RENESAS TECHNICAL UPDATE

Product Category	MPU/MCU		Document No.	TN-SY*-A0046A/E	Rev.	1.00
Title	Errata for User's Manual regarding the IIC		Information Category	Technical Notification		
Applicable Product	Renesas Synergy™ S5D9 MCU Group	Lot No.	Reference Document	S5D9 Microcontroller Group User's Manual Rev.1.30		
		All

The specified Renesas Synergy S5D9 User's Manual has incorrect statements about the IIC.

Page 1291 of 2178

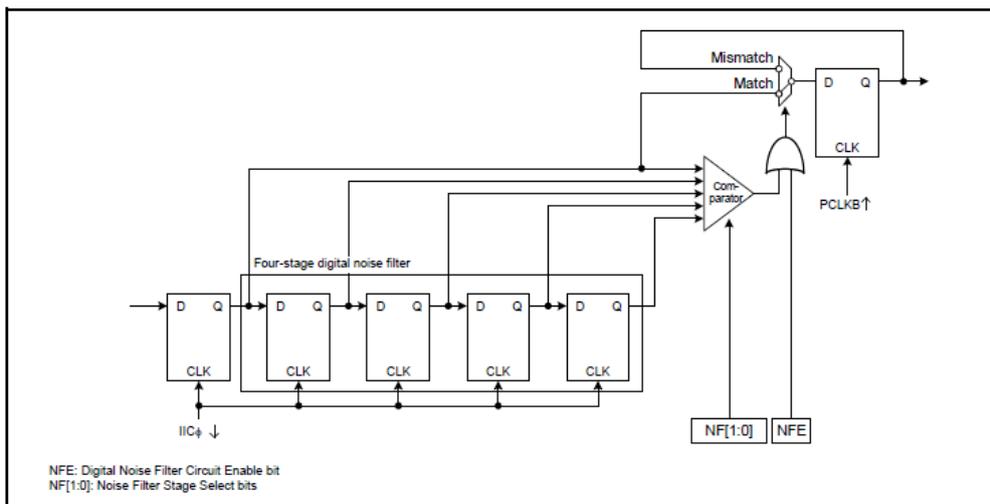
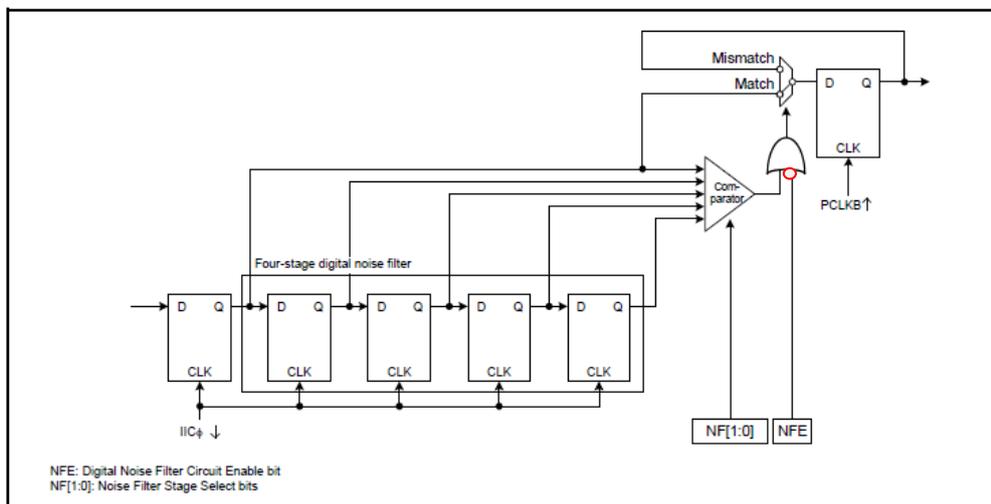
Incorrect Figure

Correct Figure

Incorrect

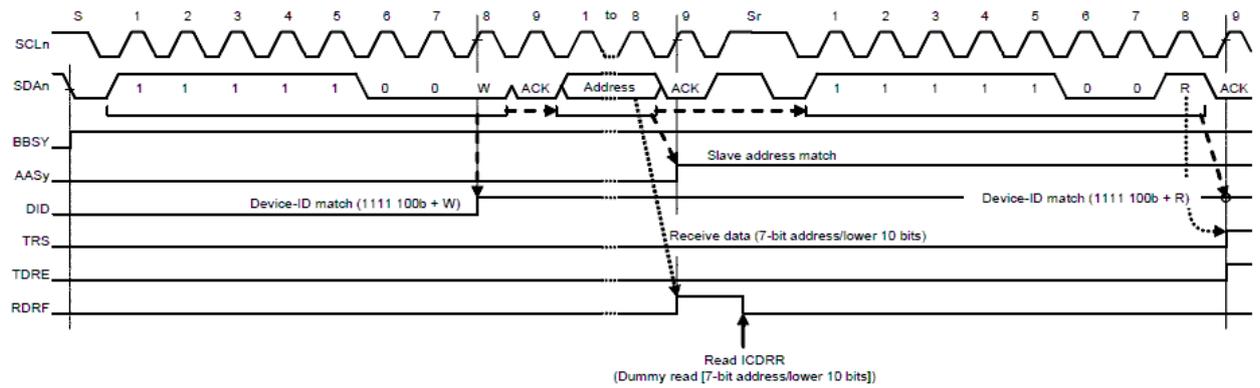
The IIC module provides detection of device-ID address compliant with the I2C bus specification (revision 03). When the IIC receives 1111 100b as the first byte after a start or restart condition was issued with the DIDE bit in IC SER set to 1, it recognizes the address as a device ID, sets the DID flag in ICSR1 to 1 on the rising edge of the eighth SCL clock cycle when the subsequent R/W# bit is 0, and then compares the second and subsequent bytes with its own slave address.

The IIC module provides detection of device-ID address compliant with the I2C bus specification (revision 03). When the IIC receives 1111 100b as the first byte after a start or restart condition was issued with the DIDE bit in IC SER set to 1, it recognizes the address as a device ID, sets the DID flag in ICSR1 to 1 on the rising edge of the **9th** SCL clock cycle when the subsequent R/W# bit is 0, and then compares the second and subsequent bytes with its own slave address.

Incorrect Figure

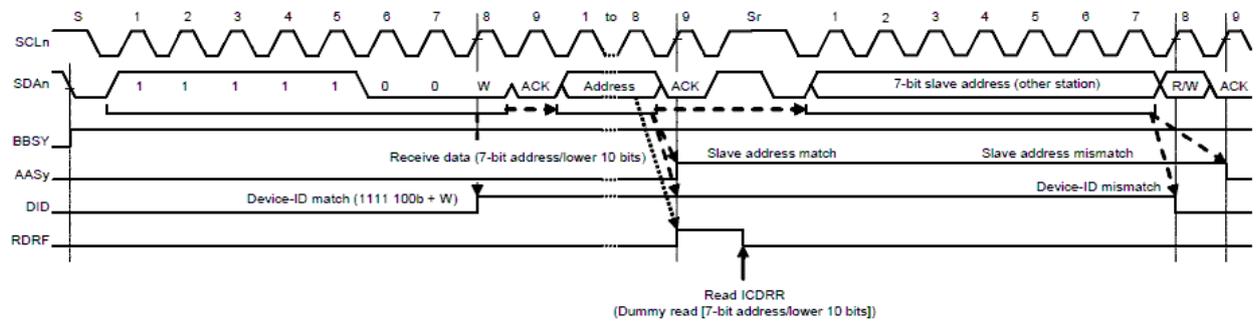
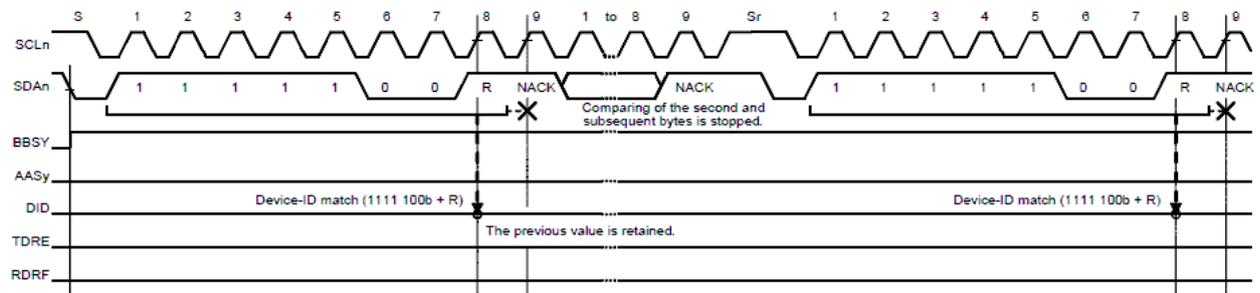
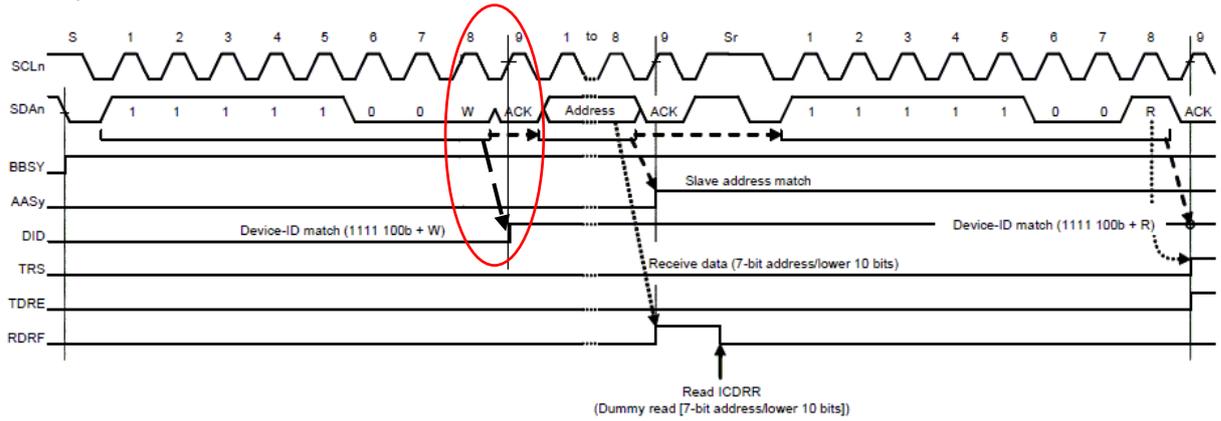
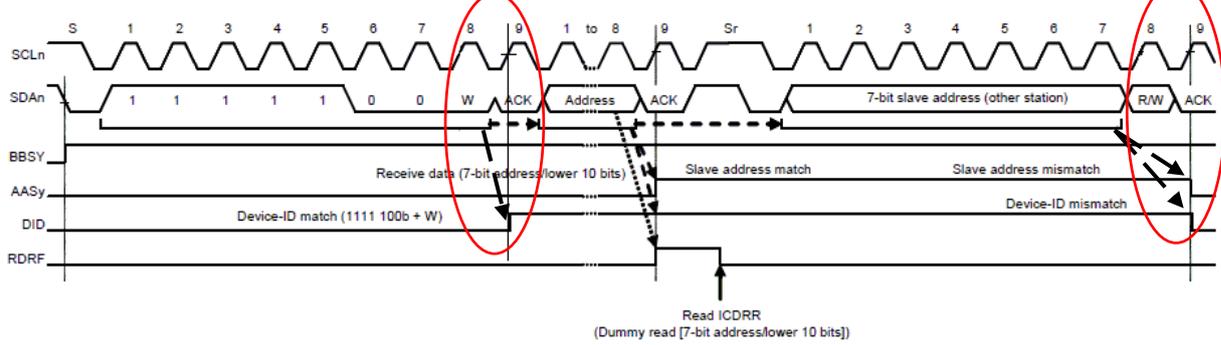
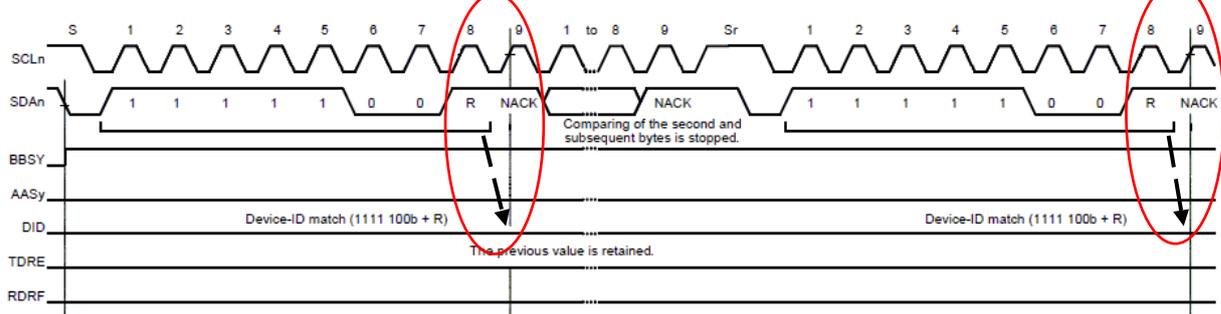
Device-ID reception

When address received after a restart condition is detected does not match the device-ID

When address before the device-ID + R does not match the slave address

Device-ID reception

When address received after a restart condition is detected does not match the device-ID

When address before the device-ID + R does not match the slave address

Incorrect Figure

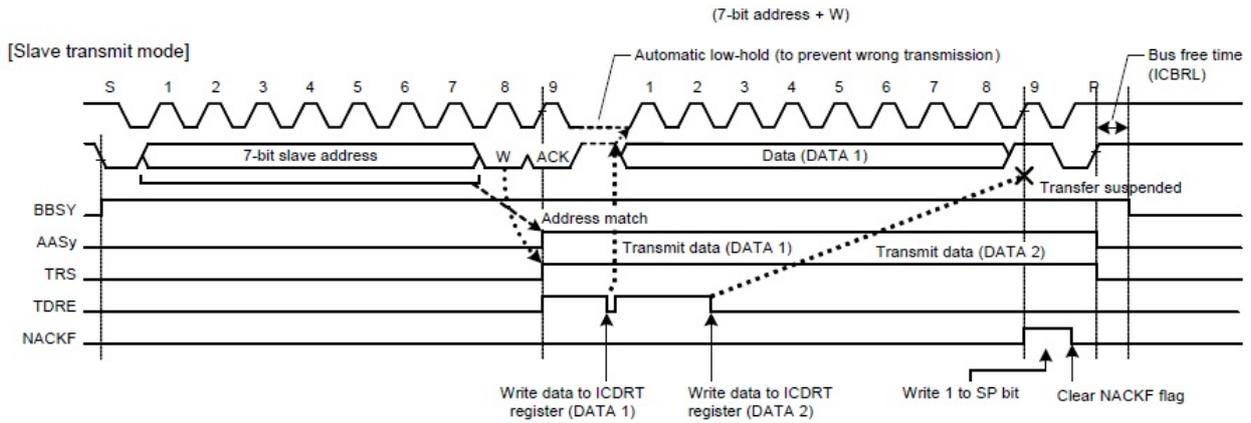
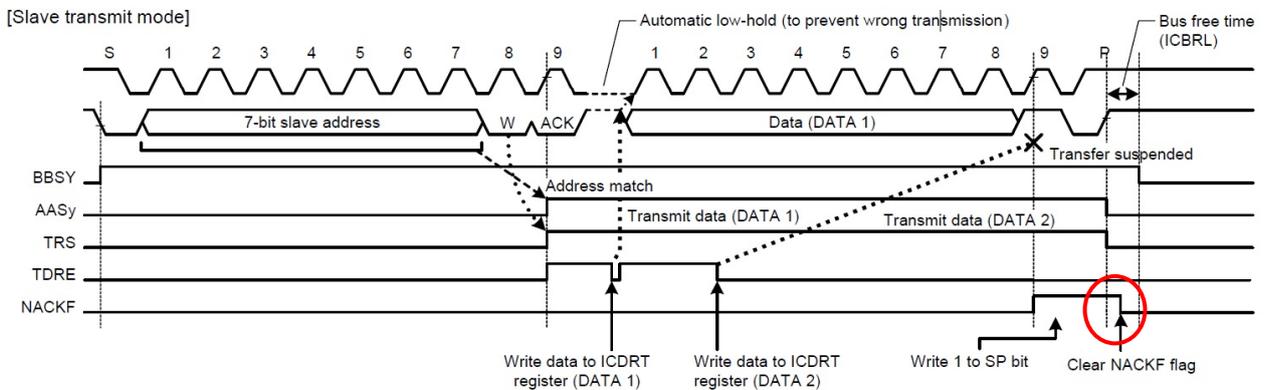
More extra clock cycles can be output consecutively by software writing 1 to the CLO bit after having read CLO = 0.

Correct Figure

If the BBSY flag is 1, SCL terminal keeps low output, if BBSY flag is 0, SCL terminal keeps high output. Additional clock cycles can be output consecutively by writing 1 to the CLO bit with software after reading the bit as 0.

Incorrect Figure

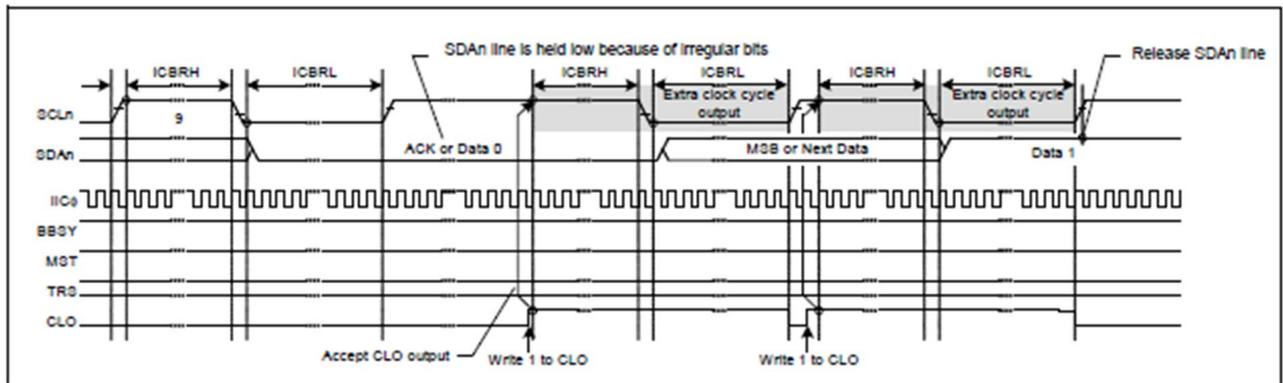
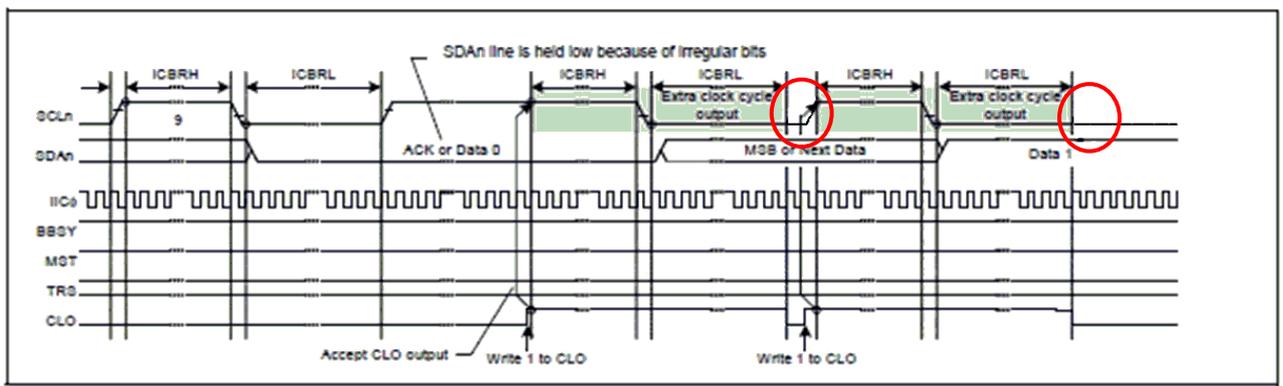
Use this function with the MALE bit in ICFER set to 0 (master arbitration-lost detection disabled). If the MALE bit is set to 1 (enabled), arbitration is lost when the value of the SDAO bit in ICCR1 does not match the state of the SDAn line.

~~Use this function with the MALE bit in ICFER set to 0 (master arbitration-lost detection disabled). If the MALE bit is set to 1 (enabled), arbitration is lost when the value of the SDAO bit in ICCR1 does not match the state of the SDAn line.~~

Correct Figure
